# Product Change Notification

PCN2022121201

**[IMB-1314 and IMB-X1314]  
PCB Rev. change to R1.02**

[Table 1]

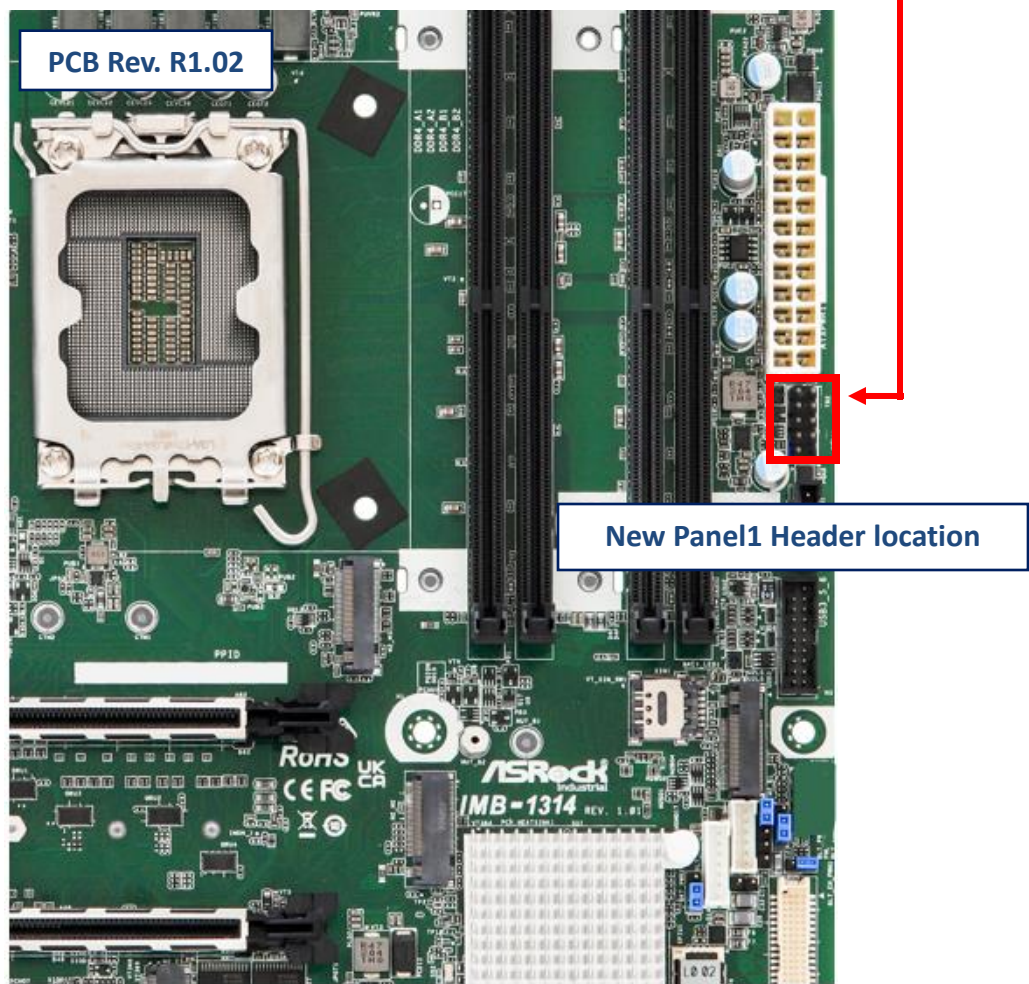
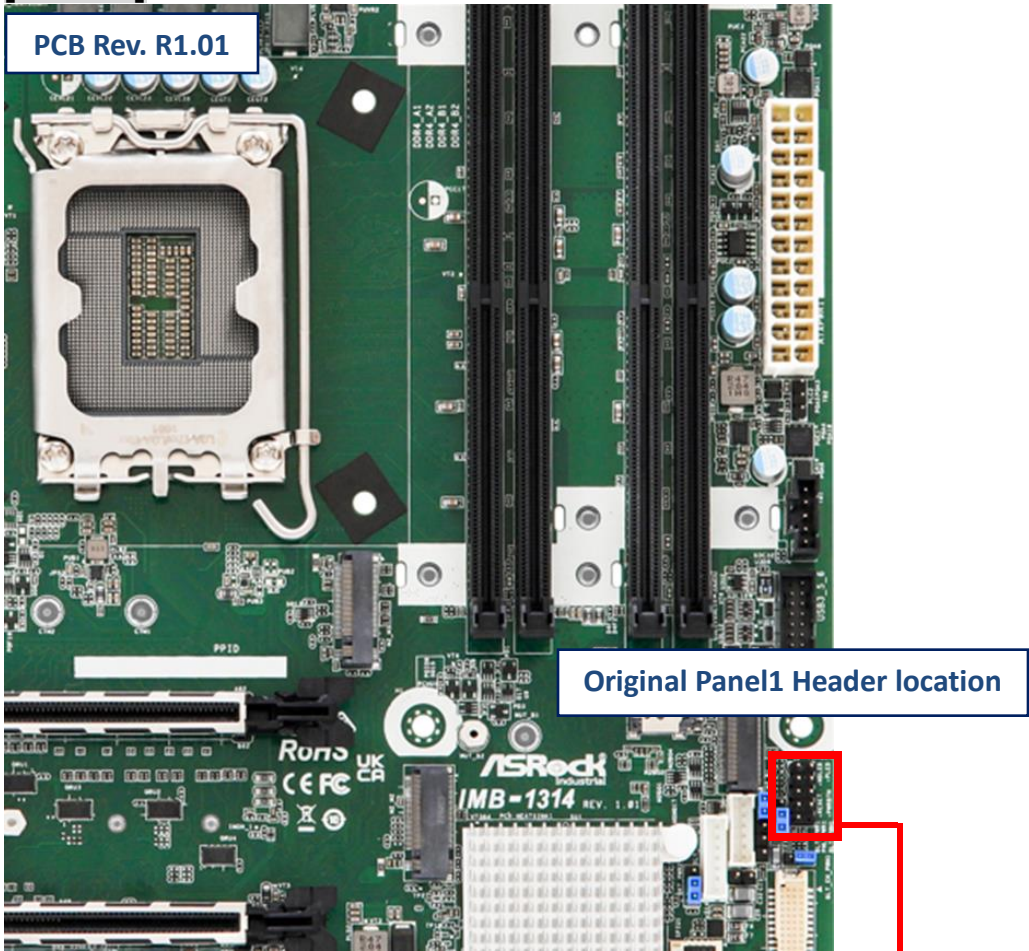
Modify PANEL1 HEADER (P/N: 12G06105010K) location.

Please refer to the **[Table 1]** to check the difference between original Panel1 header location and new Panel1 header location.
